Building or Use Permit Pre-Application
Additions/Alterations/Accessory Structures
To Detached Single Family Dwelling

Location/Address of Construction: 71 DOLE ST

Proposed Project Description: (Please be as specific as possible)
12'x 20' CARPORT 2 DOOR TRUSS ROOF

46' To Road
 18' To left of carport
 96' To Back
 To Right

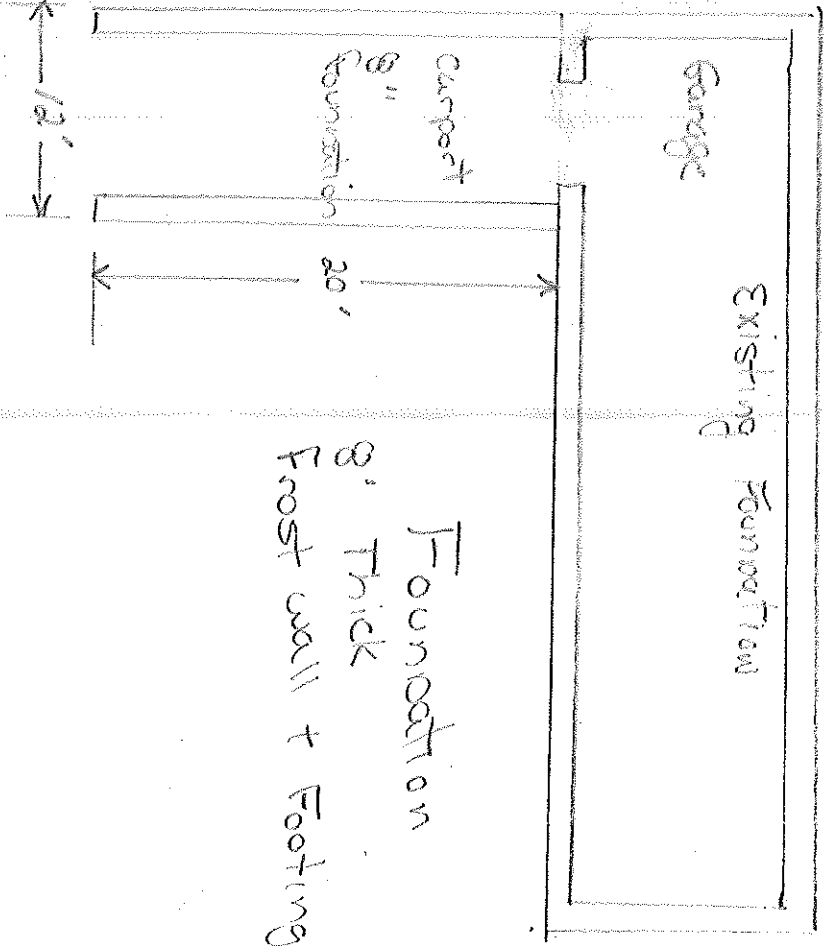
wrong - I spoke
 with contractor
 he will remeasure -
 however this setback
 doesn't affect the carport addition

R-2
 Rear Setback 25' req - N/A
 Front Setback - 25' req - 46' shown
 Side yard 12' req - 18' shown

These two
 measurements
 are correct
 per Dan Messer

OK
